State of New Mexico  
Energy, Minerals and Natural Resources

Form C-103  
Revised July 18, 2013

WELL API NO. 30-015-42797
5. Indicate Type of Lease STATE <input type="checkbox"/> FEE <input checked="" type="checkbox"/>
6. State Oil & Gas Lease No.
7. Lease Name or Unit Agreement Name Cedar Canyon 15 SWD
8. Well Number 1
9. OGRID Number 16696
10. Pool name or Wildcat SWD Devonian-Silurian
11. Elevation (Show whether DR, RKB, RT, GR, etc.) 2928'

Attachment C-103  
OXY USA Inc  
Cedar Canyon 15 SWD #1  
API No. 30-015-42797

OXY USA Inc.  
CedarCanyon 15 SWD #1  
API No. 30-015-42797

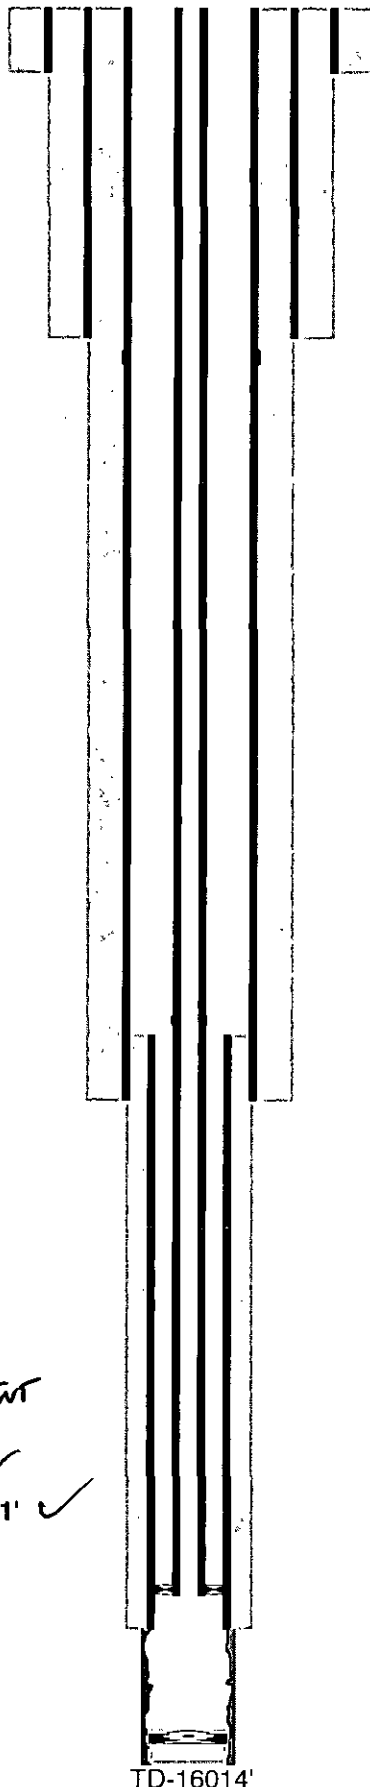
OXY respectfully requests to change the injection tubing string as follows:

- a. Stop injection operations
- b. Pull existing 4-1/2" 11.6# L-80 tubing out of the hole
- c. Run new tubing string of 5-1/2" 20# L-80 BTC to 9655' (100' above top of 7" liner) X/O to 4-1/2" 15.1# L-80 BTC to 14,781'. Both tubing strings will be lined internally with Duoline anti-corrosion lining
- d. OXY will notify NMOCD 24hrs prior to running MIT

*SWD 1570-A Requirement*

5-1/2" 20# L80 Duo-Line tbg @ 0-9655' ✓

4-1/2" 15.1# L80 Duo-Line tbg @ 9655-14781' ✓

AS pkr @ 14781'
